# 18VARIANCE1039 Caledonia Avenue Residence

Louisville Metro Board of Zoning Adjustment Public Hearing

Dante St. Germain, Planner II
October 1, 2018

#### **Elevations**

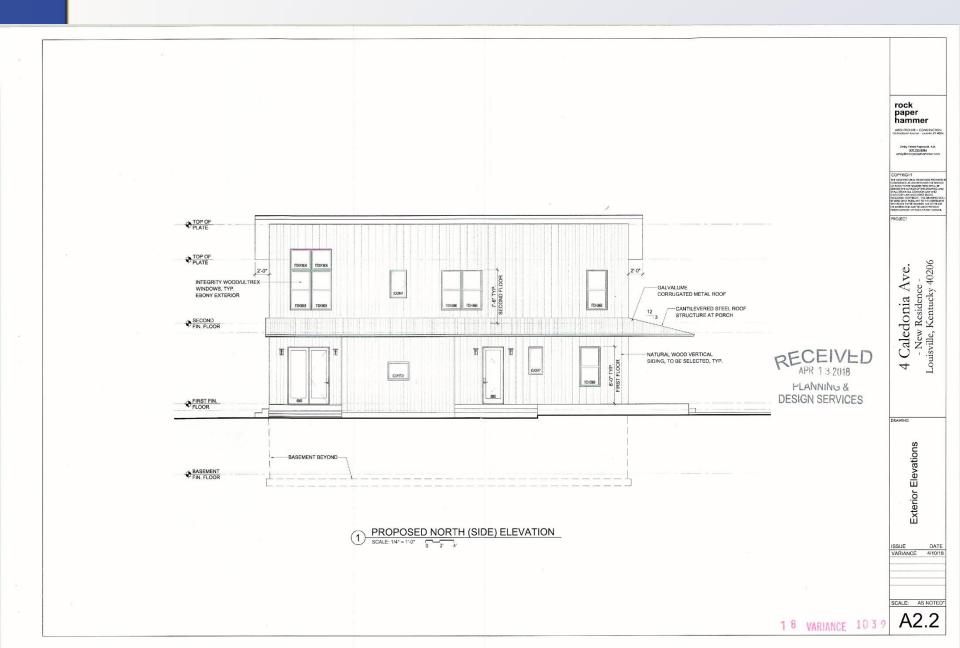
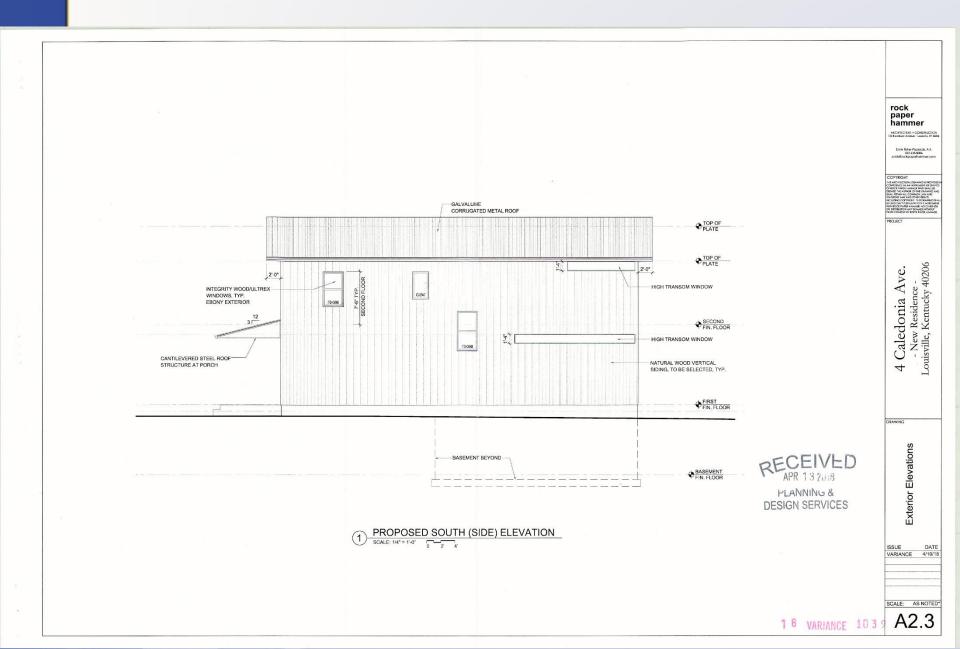
- Variance: from Land Development Code section 5.1.12.A.2.a to allow a structure to exceed the maximum allowed infill front yard setback.
- Waiver: from Land Development Code section 5.4.1.C.3 to allow a front-loaded garage to not be set back 4 feet from the front façade of the house in the Traditional Neighborhood form.

- The subject property is located in the Crescent Hill neighborhood.
- The property is currently undeveloped. The applicant proposes to construct a new singlefamily residence which is to be set farther back than the maximum allowed by infill regulations.
- The applicant also proposes to construct a frontloaded garage which is flush with the front of the house, requiring a waiver.

The variance request appears to be adequately justified and meets the standard of review.

The waiver request appears to be adequately justified and meets the standard of review.
